BULLETIN: 25933

Front Wheel Drive Lower Ball Joints

General Motors

CARQUEST® improved design K5263

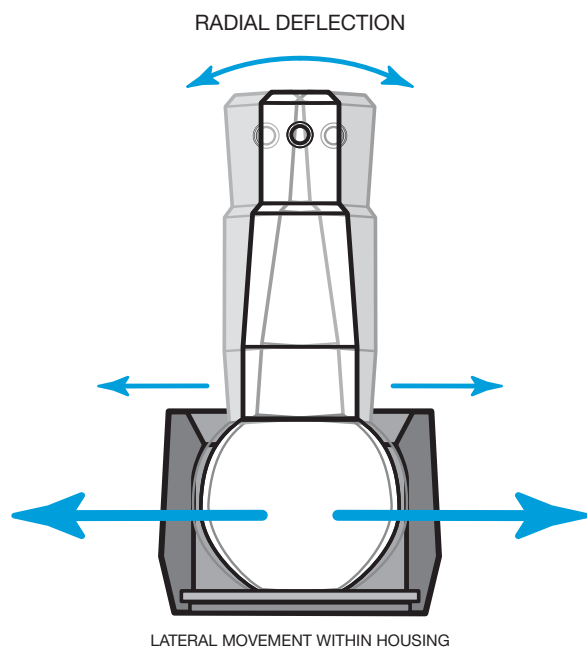
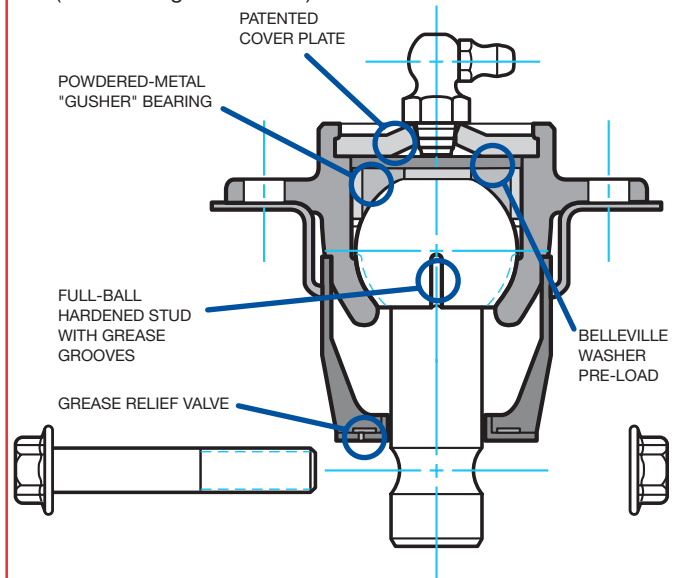
Premature ball joint wear

- Lateral deflection (side to side) loading causes excessive wear in ball joint.

- Utilizes patented CARQUEST® Chassis cover plate design and NASCAR-proven split-bearing technology, which eliminates the excessive radial deflection often experienced with high lateral loads. The ball joint assembly maintains maximum ball-to-bearing contact for greater load carrying capability.
- Belleville washer pre-load provides lower torque and stud articulation with minimal axial clearance.
- Hardened powdered-metal bearings provide a smooth, durable wear surface that extends service life.
- A flange-style sealed boot equipped with a special grease-relief valve keeps contamination out and provides a serviceable sealed environment. (see drawing for Solution)
